Project Number: 4345.01

RESPONSE TO CLAUSE 23 FURTHER INFORMATION REQUEST – PROPOSED PRIVATE PLAN CHANGE REQUEST

Your letter dated 19 April 2024 requesting further information under Clause 23 to Schedule 1 of the Resource Management Act 1991 (**RMA**) refers.

Figure 1: Layout of Pukekohe North-East Arterial relative to the Site and neighbouring site

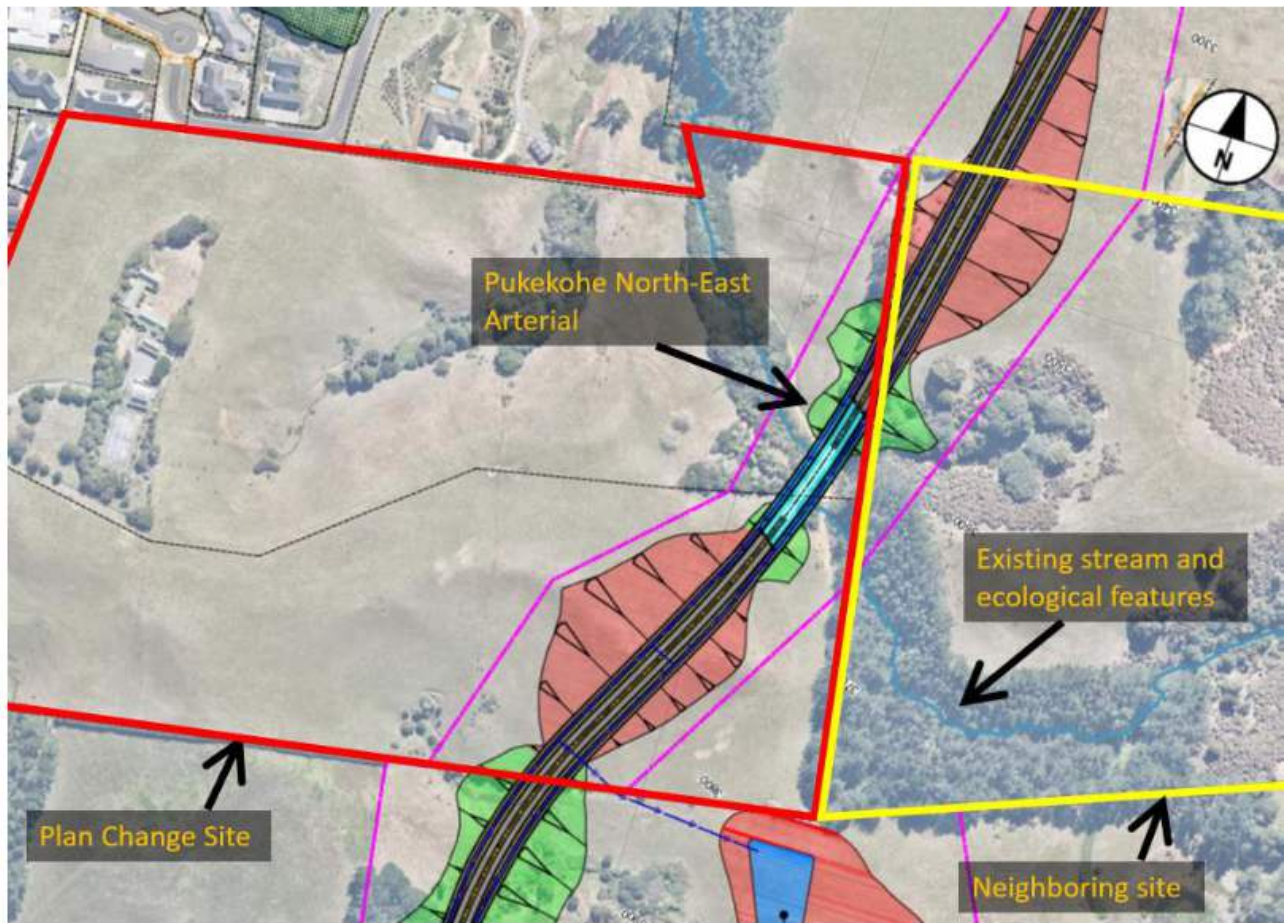
- P2 Please confirm if any consideration was given to the provision of a road connection between the south-eastern corner of the site and the adjoining FUZ site.**

- The layout of the Pukekohe North-East Arterial, relative to the Site and the neighbouring site (109 Runciman Road, Pukekohe) is shown in Figure 1
- Figure 2 shows the roading connection to the Pukekohe North-East Arterial in the south-east corner of the Site, based on the roading concept plan.

Therefore, we consider that the Precinct provisions should provide flexibility about whether a roading connection between both sites should or should not be provided.

Figure 4: Isochrone for public transport accessibility within 30 minutes of the Site

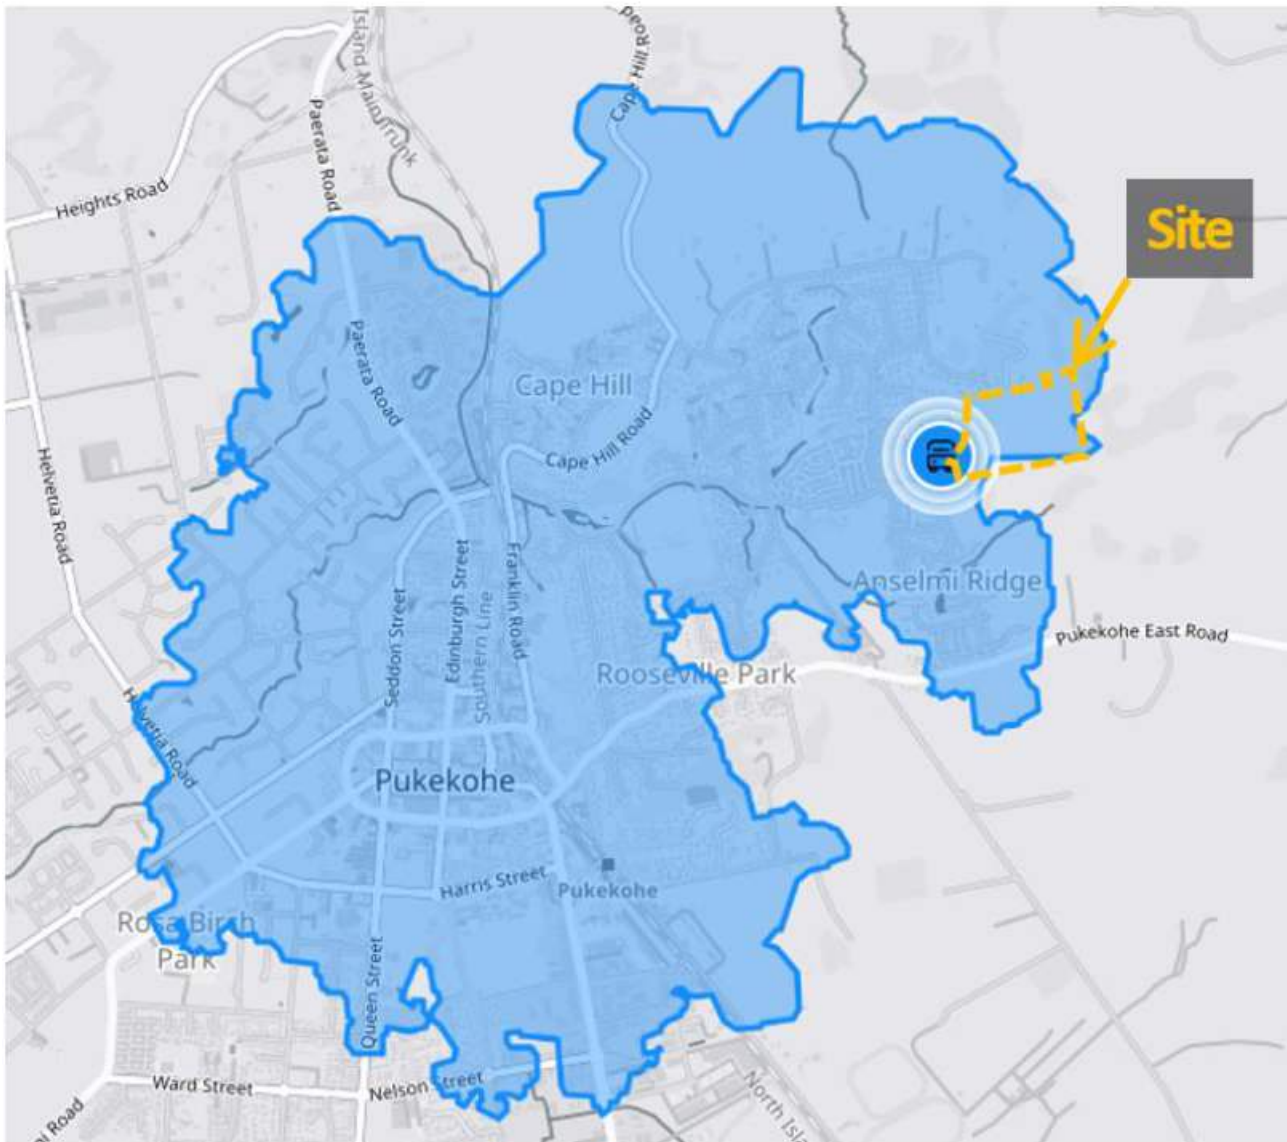
- T1** Please provide an assessment on the ability of the subject site to fulfil the functional transport requirements for the Residential – Mixed Housing Urban Zone, including:
- Creation of walkable neighbourhoods, which requires convenient proximity of residential areas to local services and opportunities, such as retail activities, education and health services.
 - Proximity to the public transport network
- One potential tool for such assessment could be isochrone style plans to indicate walking and cycling distances from key services and land use activities.

Figure 4 shows 30 minutes of public transport accessibility associated with the Site. This figure is an isochrone using the online TravelTime tool³ and shows the public transport coverage is consistent with the area served by the 391 bus route.

In summary, Flow consider the Site to have good public transport access.

Figure 7: Anselmi Ridge trip departures to the wider area, Waka Commuter tool using Census 2018 data

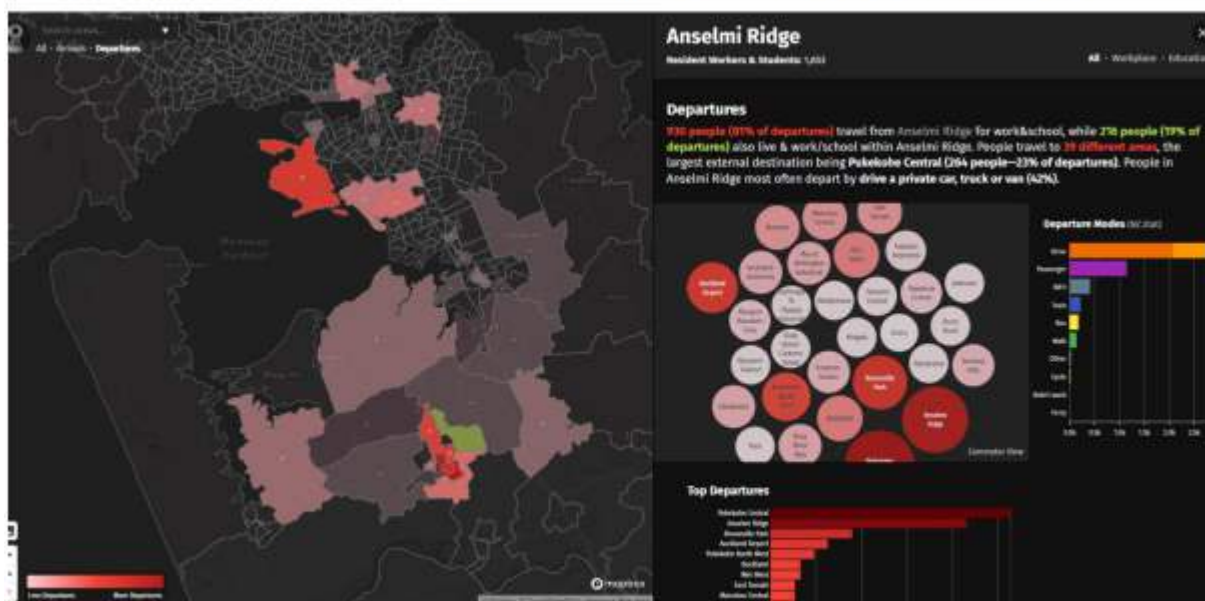
T2 Please provide an assessment of trip distribution for a scenario that includes the completion of the North East arterial road (including access to it from the subject site) and other improvements to the adjoining strategic road network.

Figure 7 and Figure 8 (below) show the trip distribution patterns for people departing the Anselmi Ridge zone, which shows how people living in this area depart for either work or school. This image is from the Waka Commuter tool³, which is based on using travel to work data in different zones from the 2018 Census. This data shows that:

- 19% of people stay within the area for work or school
- 81% of people depart the area for work or school. Of these departures, the most common destinations were (zones with more than 4% of the total trips)
 - o Areas within Pukekohe
 - Pukekohe Central (23%)
 - Roseville Park (8%)
 - Pukekohe North West (4%)
 - o Auckland Airport (6%).

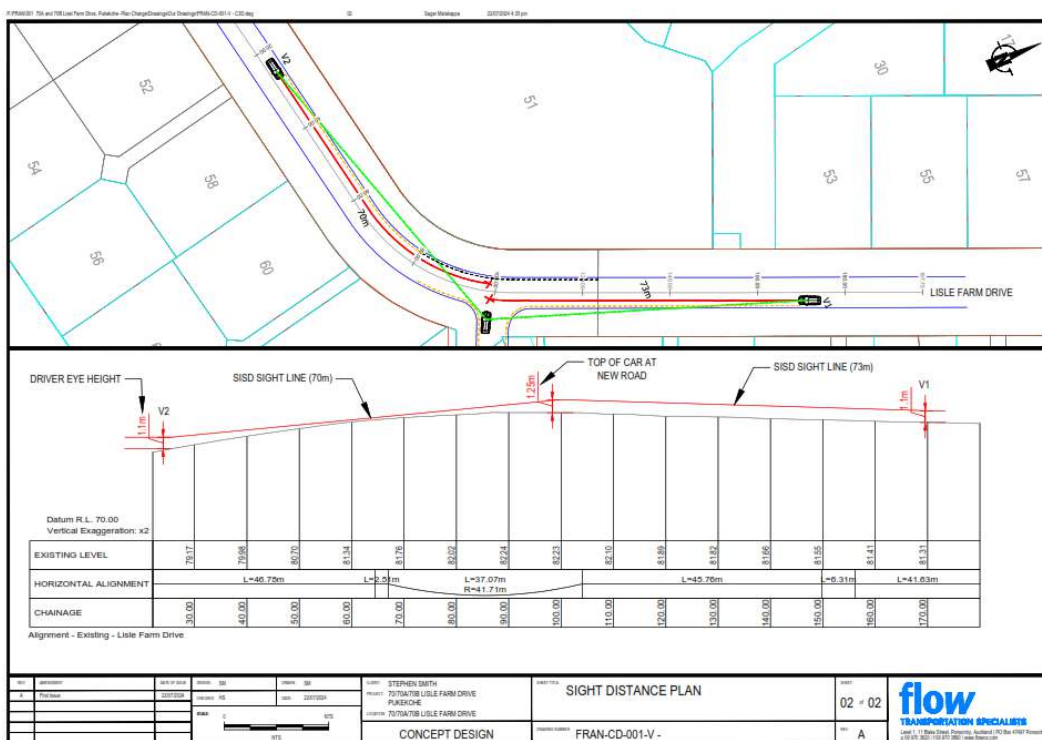
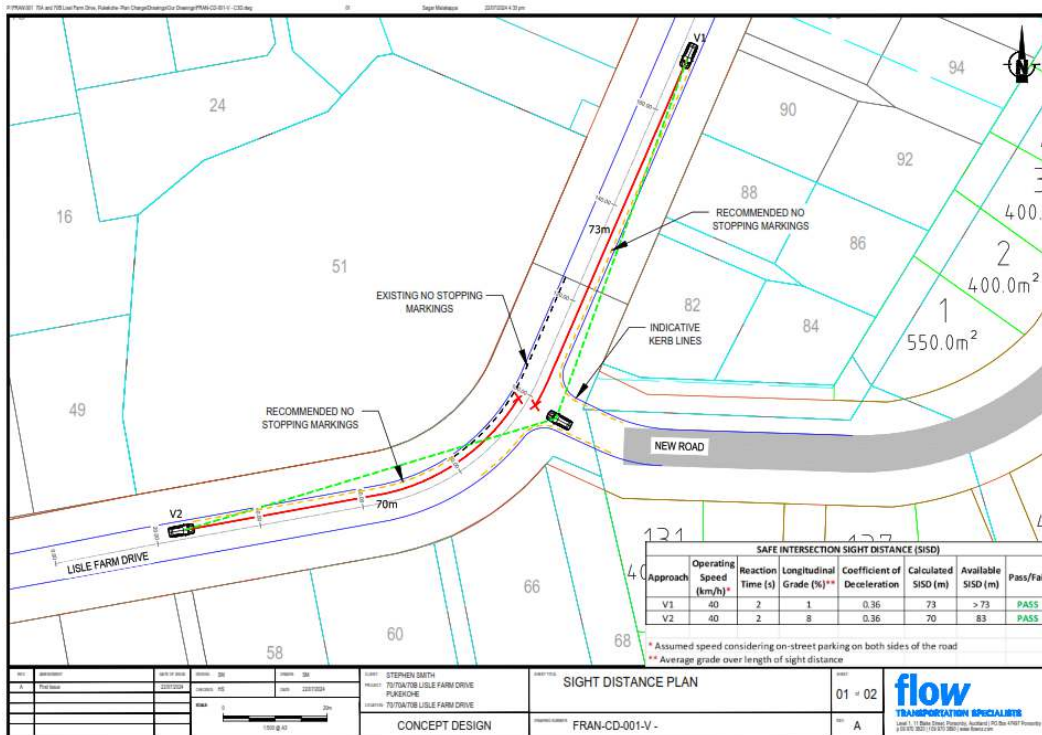
- T3 Please confirm that new roads and transport connections within the subdivision can achieve compliance with appropriate Standards for vertical alignment, e.g., a maximum longitudinal footpath gradient of 12.5%, as stipulated in AT's Transport Design Manual (TDM).

Please refer to the updated roading plans prepared by Birch Land Development Consultants, provided as part of the Clause 23 responses.

The roading plans show that the gradients of each road will not exceed 12.5%.

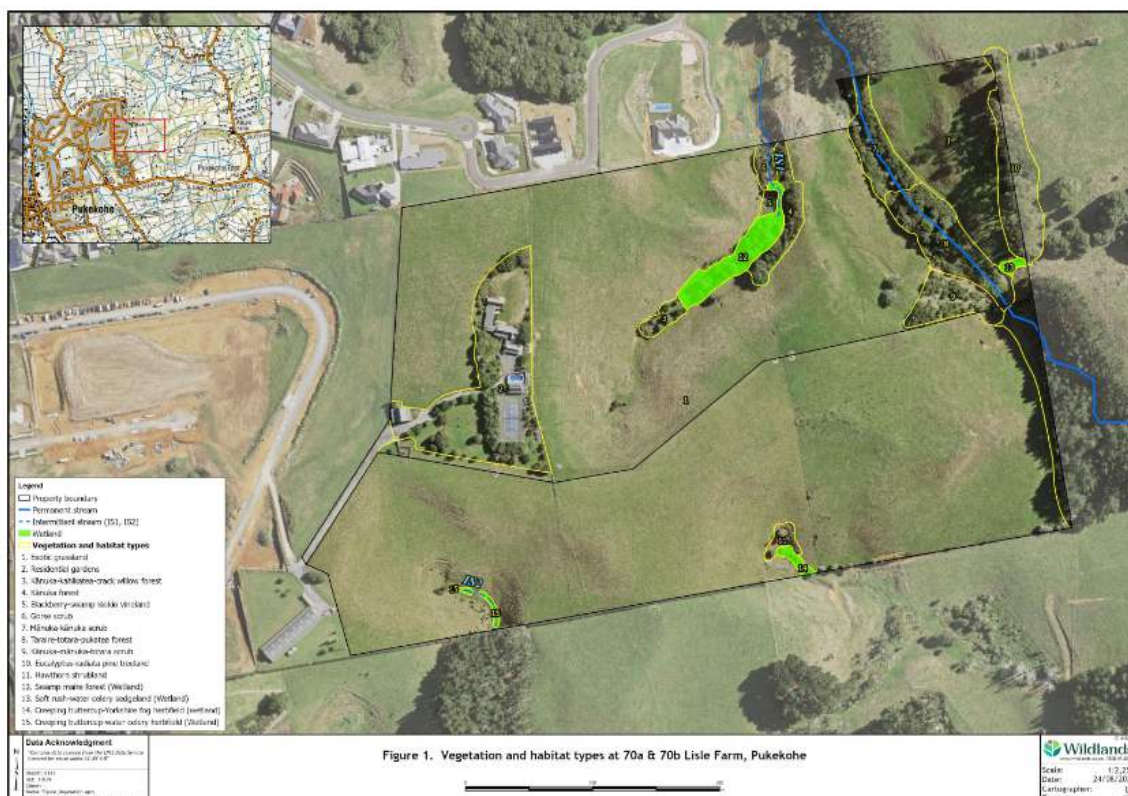
- L1** Please confirm whether the 'Paerata – Pukekohe Structure Plan Landscape and Visual Assessment Background Investigation for Auckland Council' (Opus, 2017) was reviewed and whether this broader landscape analysis contains any pertinent information to inform the PPC.

This document was reviewed as part of the LVA. The document identified potential adverse landscape character effects from inappropriately located built form into the skyline on the northern steep face of Pukekohe East Crater rim, including the ONF, and potential loss of landmark /placemaking value - near the southeast of LCA 12; and potential adverse visual amenity effects from inappropriately located built form into the Pukekohe East Crater rim – northern area of LCA, southeast of LCA 13.

I considered that the visual and physical integrity of the Pukekōhe East tuff ring ONF would not be adversely affected by the proposal and would remain the dominant natural feature within the area.

Figure 1 – illustration of the different open space width demands relevant to ‘park edge roads’.

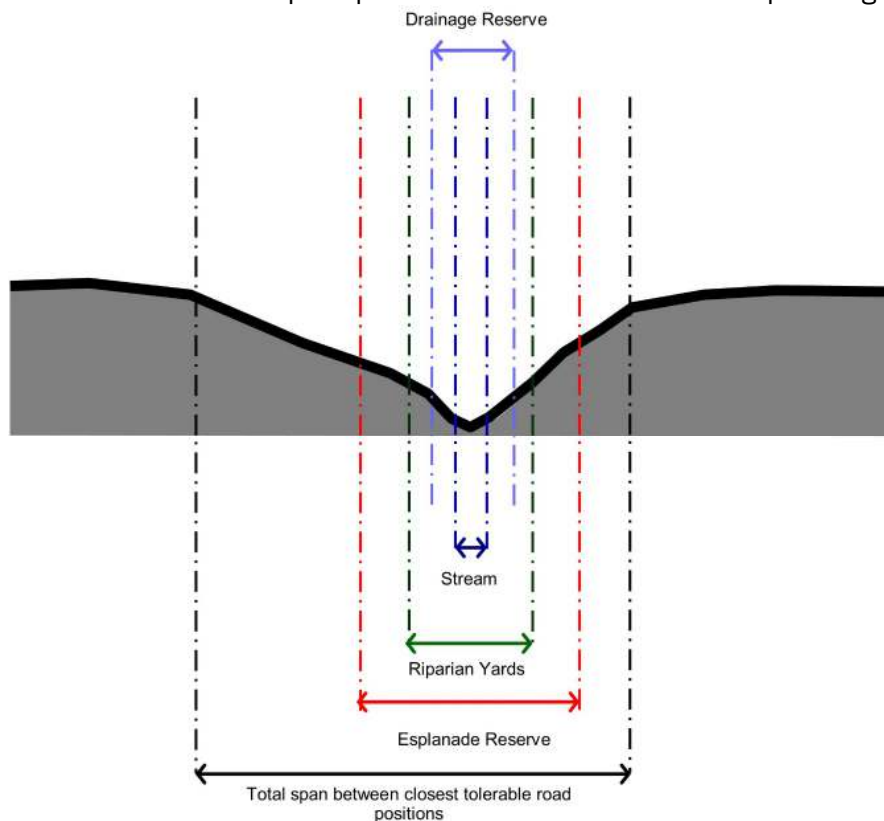
Please provide further analysis of how suitable connectivity will be achieved with the existing urban environment to the west if a full street connection to Lisle Farm Drive is not achieved.

I refer to Figure 1 where I have illustrated the issue of the ‘open space gap’ (this is taken from my evidence on the PC76 Private Plan Change – Kohe Precinct, south of Pukekohe East Road).

In summary, a Council needs to be able to confirm that it will acquire all of the land between a stream and the closest workable position for a road (that needs to separately also be acceptable to AT), before a park edge road can be itself assumed to be viable – and that is just to establish viability; the discussion on overall merit about what and where a park edge road might actually be desirable would still need to
